Enclosed is our response to your request for additional information identified in your letter to H. G. Parris dated November 15, 1982, subject, "IE Bulletin 80-06 - ESF Reset Controls." If you have any questions, please call Jim Domer at FTS 858-2725.

ENCLOSURE
REQUEST FOR ADDITIONAL INFORMATION
IE BULLETIN 80-06 - ESF RESET CONTROLS
BROWNS FERRY NUCLEAR PLANT
DOCKET NOS. 50-259, 50-260 AND 50-296

47WG10-73-1
 FIGURE 1

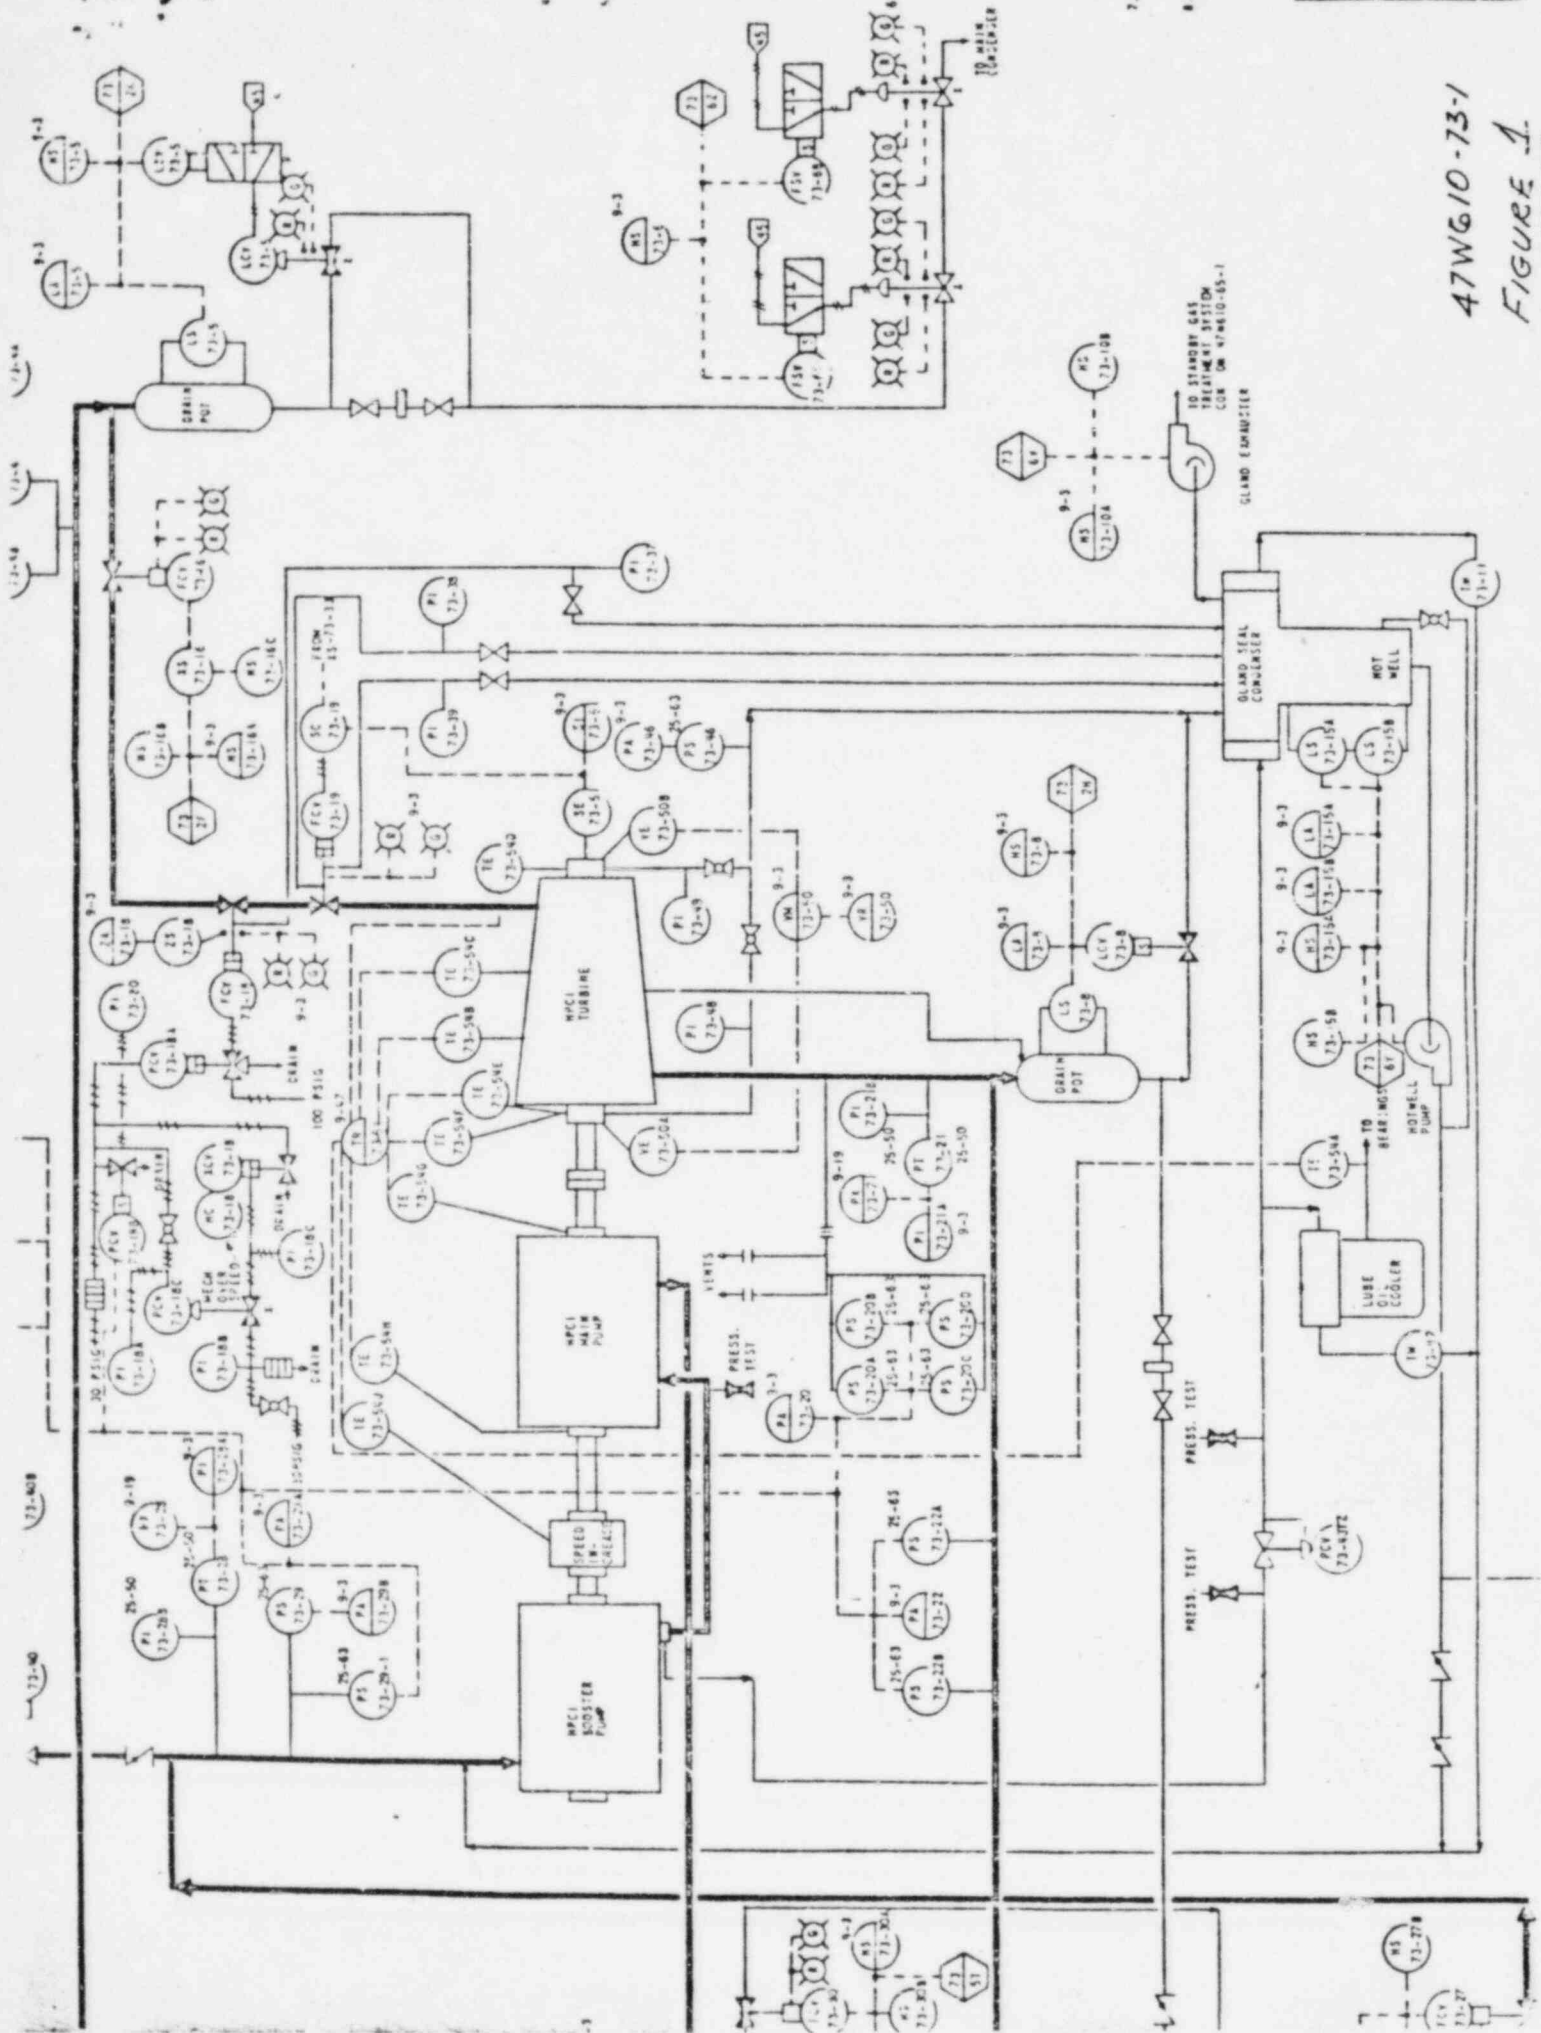
HPCI Gland Seal Condenser Blower

Figure 1 (copy attached) is a mechanical diagram showing the seal leakage control equipment used for Browns Ferry's BWR HPCI systems. The system utilizes an auxiliary condenser operating at subatmospheric pressure which is connected to the turbine shaft seals and the valve stem seals in the steam supply line valves. This arrangement results in process steam and atmospheric air entering the condenser where it is subjected to a spray provided by a line from the main HPCI pump discharge. This spray flow and the condensed steam leakage are transferred to either the main pump inlet or the clean radwaste system by the condensate transfer pump; the noncondensable gases accumulating in the condenser are returned to the standby gas treatment system by the vacuum pump (gland seal condenser blower/gland exhaustor).

Failure of the gland seal exhaustor to function will allow noncondensables to vent into the general HPCI area rather than being preferentially vented to the standby gas treatment system. This situation is undesirable from personnel radiological hygiene considerations since the noncondensables are slightly radioactive. The status of the exhaustor does not, however, affect the ability of the HPCI to perform its safety function. Therefore, the requirements of the bulletin are not applicable in this case.
